SUPPLEMENT
16 JULY 1954

SUPPLEMENT TO
TM 11-851
RADIO SET SCR-244-D
AND
RADIO RECEIVERS
R-274A/FRR,
R-274C/FRR,
R-320A/FRC,
R-483/FRR,
AND
R-483A/FRR

The following information, published on Order No. 25693-Phila-53 supplements TM 11-851, October 1953. The equipment covered in this supplement is:

Figure 102.1. Radio Receiver R-620/FRR, 501

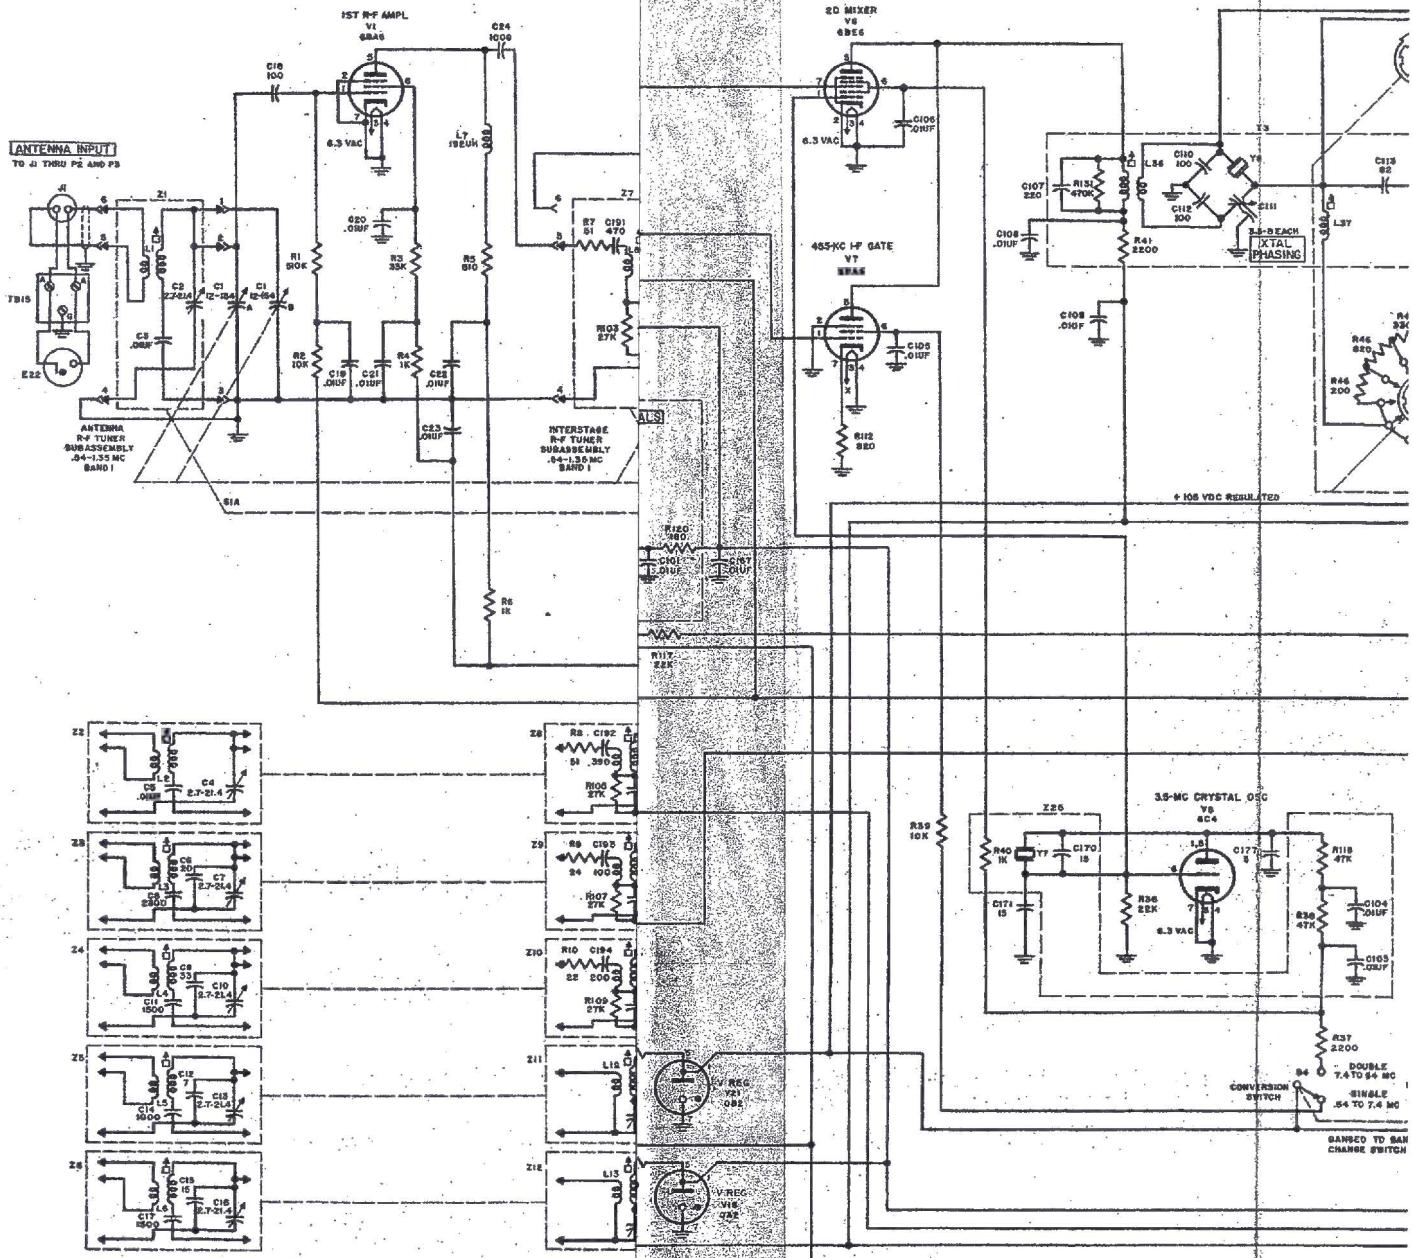
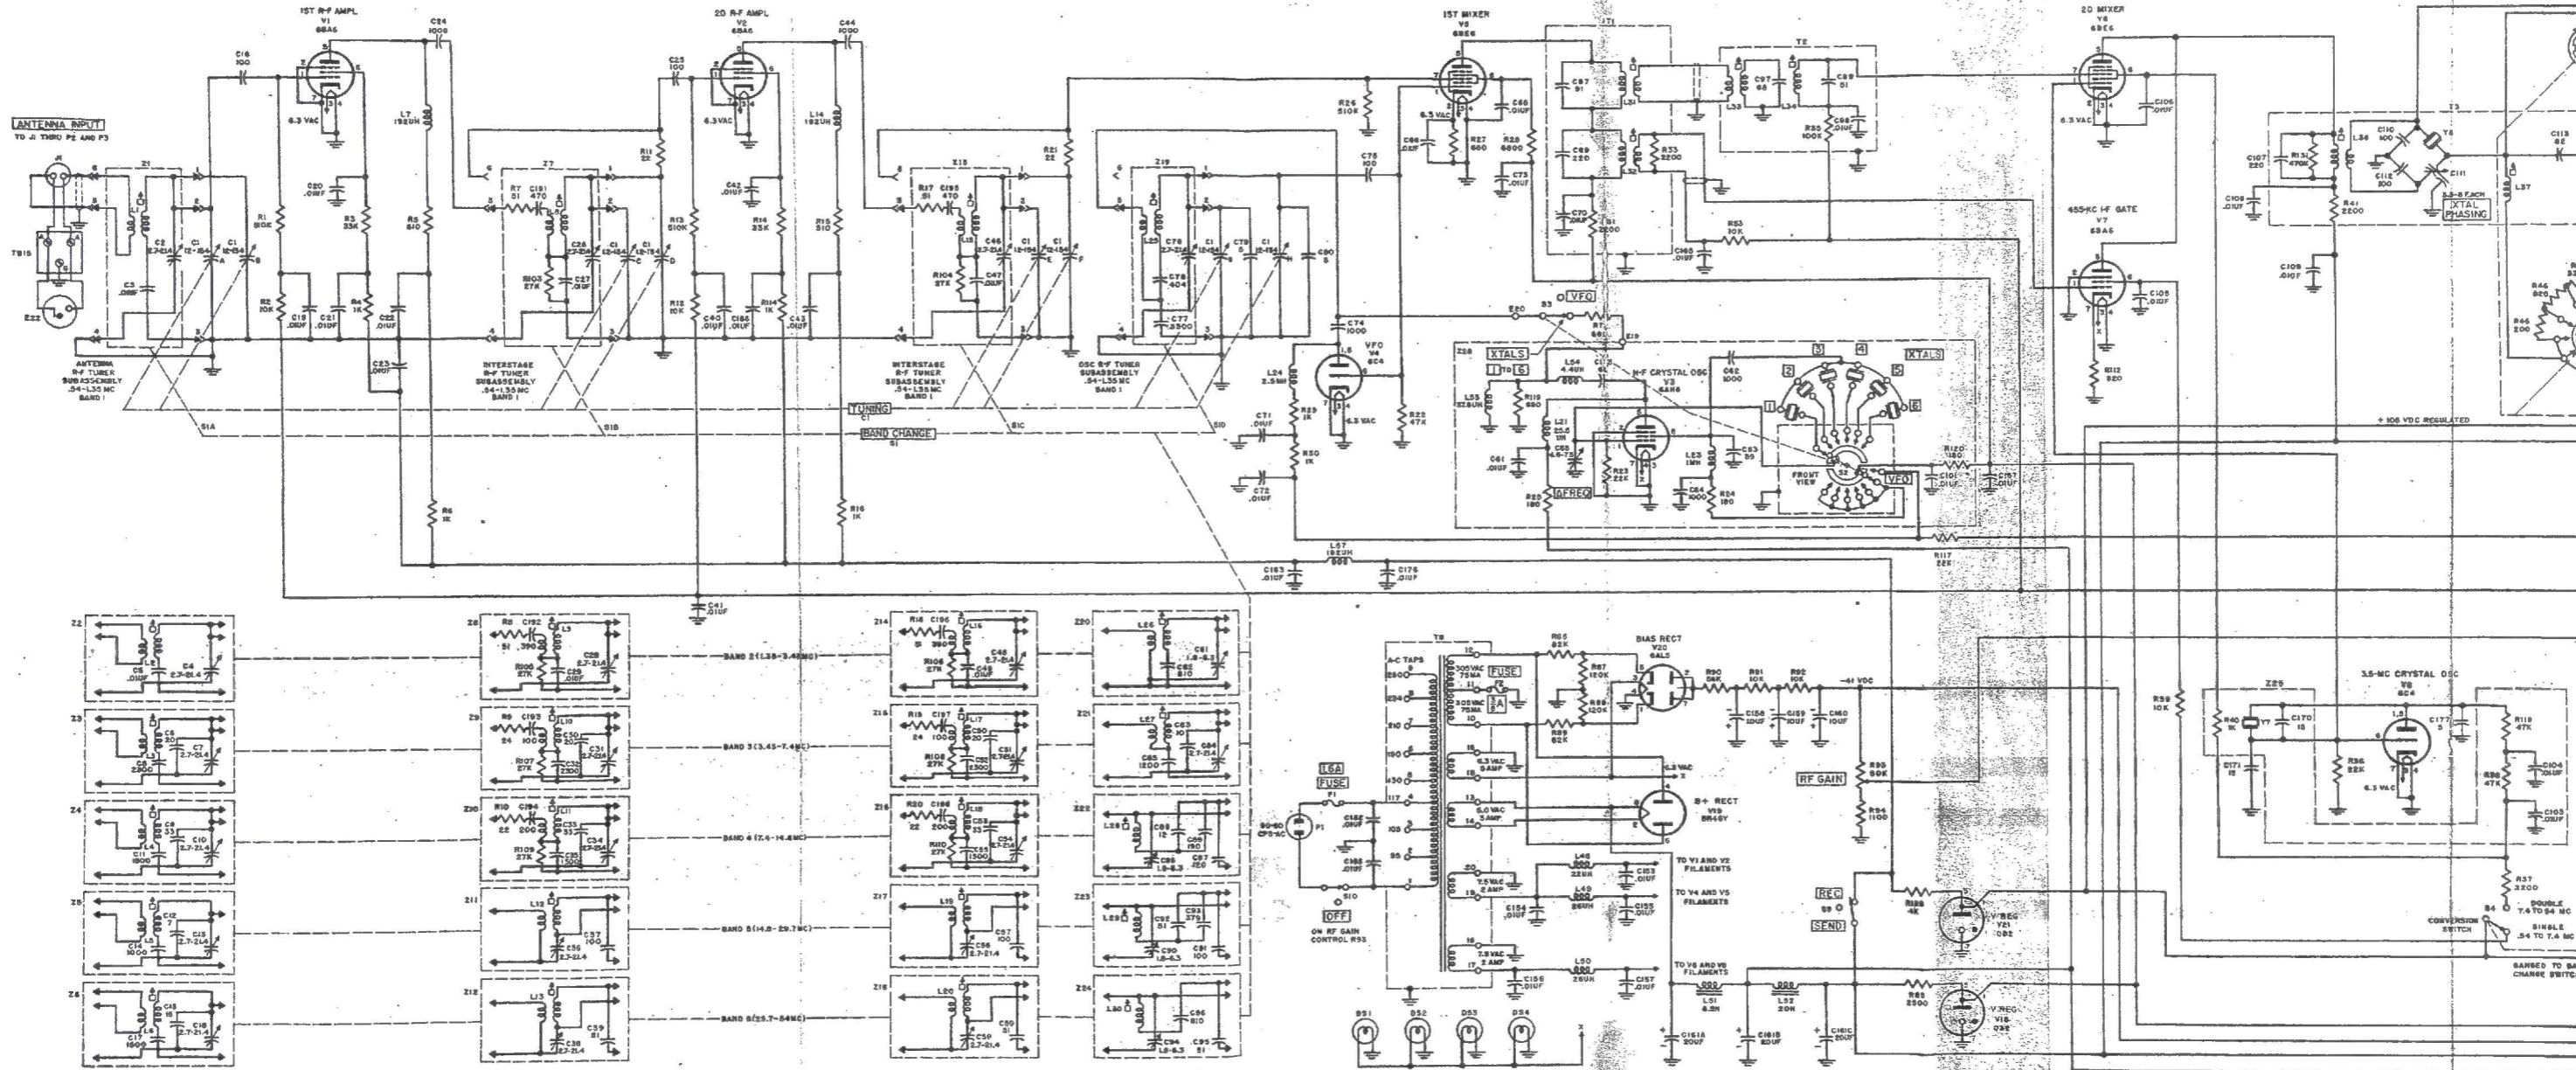
Figure 102. Add figure 102.1 after figure 102.

Figures 97 through 102. Add pilot lamp circuitry to schematic diagrams, as shown in figure 102.1. Figure 102. Delete "C103" shown twice.
